High Performance Computing Platform II (HPC II) V2 Evaluation Board Errata

1 Overview

Document Number: MCEVALHPC2ERR

Table 1. Summary of Correctable Taiga Errata

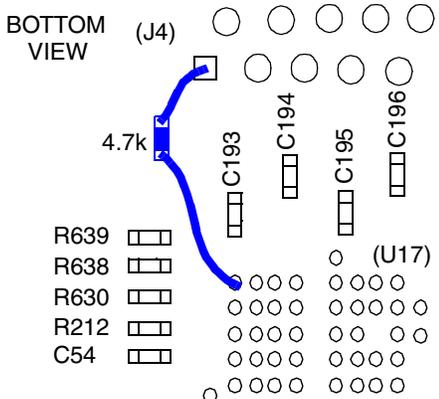
#	Problem/ Respin Resolution	Errata Correction/ Work Around
1	<p>MDIO net requires pull-up resistor. Ethernet PHYs may not function correctly without it.</p> <p>Connect 4.7 kΩ resistor from U17 pin M1 (corner via on bottom of board) to J4 pin 1.</p>	<p>Connect 4.7 kΩ resistor from U17 pin M1 (corner via on bottom of board) to J4 pin 1, as shown below:</p>  <p style="text-align: center;">BOTTOM VIEW</p> <p>Note that on some early boards, a 4.7 kΩ resistor is connected from U11 pin M1 to J22 pin 1. This is also acceptable because the MDIO signal is shared by the PHYs and may be pulled up at either location.</p>
2	<p>U47 VCC not connected to VCC_HOT_5, preventing power switch operation.</p> <p>Correct typo in component property in schematic to “VCC_3.3=VCC_HOT_5.”</p>	<p>Connect U47 pin 5 to U66 pin 5.</p>
3	<p>R10 populated on initial build.</p> <p>None; assembly error.</p>	<p>Remove R10 (top right quadrant of board, between DIMM socket 2 and L2).</p>

4	<p>R114 missing.</p> <p>None; assembly error.</p>	<p>Populate R114 (bottom of board beneath COP HEADER) with 0 Ω resistor.</p>
5	<p>Current limiting prevents TSI108/TSI109 power supplies (VCC_1.2, VCC_1.8, OVDD, and VCC_3.3_REG) from powering up.</p> <p>Either:</p> <ul style="list-style-type: none"> • Revise current limit estimates and resistor value calculations OR • Change assembly option and component values in schematic. 	<p>Reconfigure power limiting as follows:</p> <ul style="list-style-type: none"> • Remove R325, R330, R332, and R335. • Populate R9, R10, R13, and R14 with 1.5 kΩ resistors. • Change R323, R756, R757, and R773 to 56.2 kΩ resistors. <p>All components are near the respective power supplies.</p>

Table 1. Summary of Correctable Taiga Errata (continued)

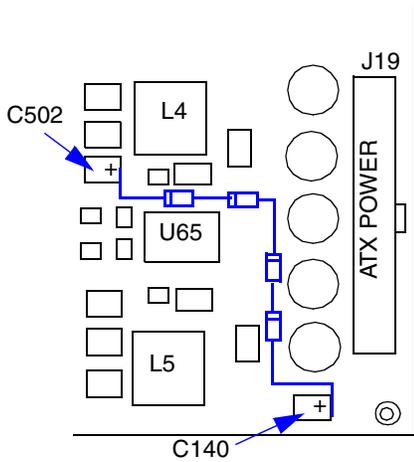
9	<p>U65 PWM #1, which supplies VCC_2.5, not switching when preliminary work around for Erratum 6 (three-diode stack) is implemented. If the diode drops are lower than expected, the VCC_2.5 supply can be above 2.5 V, in which case the switcher does not supply or regulate the voltage. As a result, the VCC_2.5 supply may be powered entirely by VCC_3.3 supply via the diode stack.</p> <p>None. (See Erratum 6.)</p>	<p>As a work around to address Erratum 6, three 1N5817 diodes in series were added between VCC_3.3 (at C140) and VCC_2.5 (at C502). Three diodes has been found to be insufficient, and four are now recommended:</p>  <p>The diagram illustrates the power distribution network for VCC_2.5. It shows the ATX POWER connector (J19) connected to a series of components: inductor L4, capacitor C502, inductor L5, capacitor C140, and a diode stack. The diode stack is connected to the VCC_2.5 rail. The diagram highlights the path from the ATX POWER through the diode stack to the VCC_2.5 rail, with arrows pointing to C502 and C140.</p>

10	<p>When diode stack is present, which pulls VCC_2.5 rail up with VCC_3.3 (ATX) rail, glitch on VCC_2.5 supply ramp occurs when PWM subsequently begins switching.</p> <p>Under review.</p>	<p>Under review. Preliminary work around of increasing the capacitance of C_{ss} (C541) has been found to cause unacceptably slow ramp time of VCC_2.5, resulting in unreliable board operation, and has been retracted.</p>

Table 1. Summary of Correctable Taiga Errata (continued)

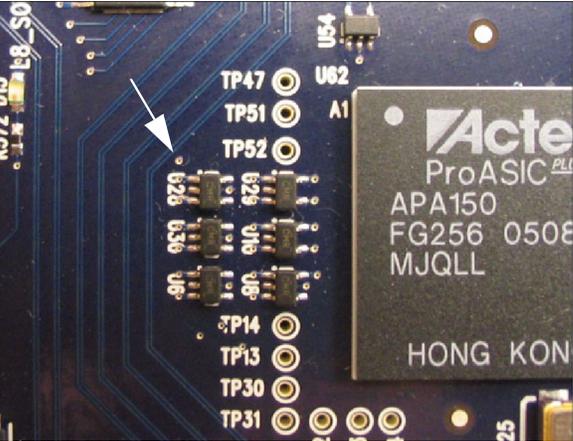
#	Problem/ Respin Resolution	Errata Correction/ Work Around
11	<p>Glitching on PCIRST* signal by FPGA at POR causes erratic SATA behavior.</p> <p>Under review.</p>	<p>Disconnect PCIRST* signal from FPGA by drilling out via near U28, as shown in the figure below. Caution: this via is surrounded by traces on internal layers, in addition to the SATA channel signals on the top layers. Great care must be taken to not damage these traces. A #78 drill bit is recommended.</p> 
12	<p>Due an error in the logic, the following TICK (FPGA) registers are not accessible in Rev 4 of the TICK:</p> <ul style="list-style-type: none"> • TPWML (inaccessible) • TPWMH (inaccessible) • TISR (inaccessible) • TMON1 (inaccessible) • TDOR (register does not exist) <p>Because the functions of the TDOR register were incorporated into the TMON1 register, TDOR is not implemented in the logic. Note that the TICK revision can be determined by reading the TVER register. (See the <i>HPC II User's Guide</i> for more information.)</p> <p>TICK logic fixed in Rev 5 to correct internal register addressing for TPWML, TPWMH, TISR, TMON1. Correct <i>HPC II User's Guide</i> to reflect removal of TDOR register.</p>	<p>The inability to access the affected registers prevents the use some advance system features such as CPU fan speed control, but the missing functions are not vital to system operation. If these advanced features are desired, then the TICK must be reprogrammed with the Rev 5 (or later) image.</p>
